Elecraft XV Transverter Builder's Alert

Bypass Capacitor Change

Revision B, April 30, 2009

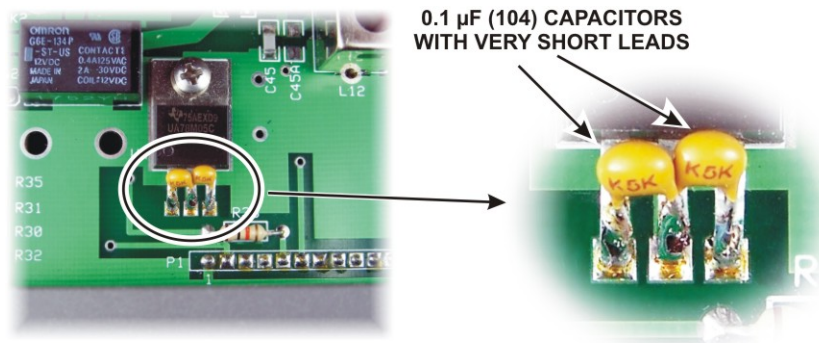
Install the two 0.1 μ F (104) capacitors between U4's center and outer pins as shown below. Solder the capacitors directly the U4's pins with very short leads. Hint: Bend the capacitor leads and hold them with your pliers while tacking one lead onto U4 with your soldering iron carrying a small drop of solder. Then solder the other lead, clean up the first connection if needed, and trim off the excess leads.

Check the resistance between the center pin and each outside pin using your DMM. It must be greater than 500 ohms to confirm no shorts between U4's pins.

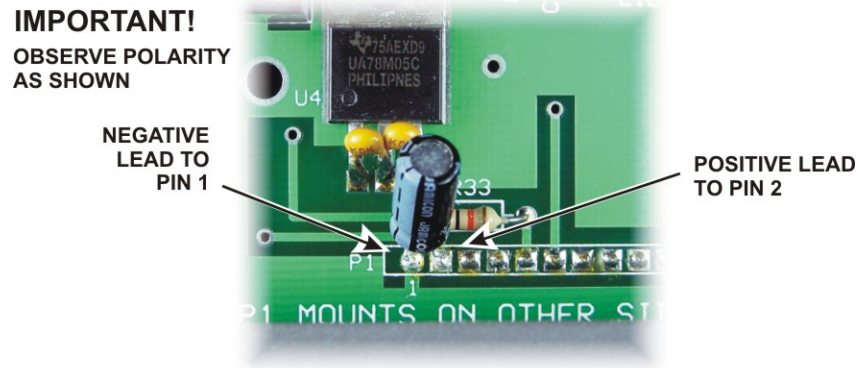
- Solder the 10 μ F (10) electrolytic capacitor to P1 pins 1 (negative) and 2 as shown below using short leads. **Be sure to connect the negative lead to pin 1 as shown!**

- Check the resistance between P1 pins 1 and 2. It must be greater than 500 ohms to confirm no short between the pins.
- Replace the top cover. Ensure the top cover and all case screws are tight. A solid mechanical and electrical connection between all case parts is important for stable operation.
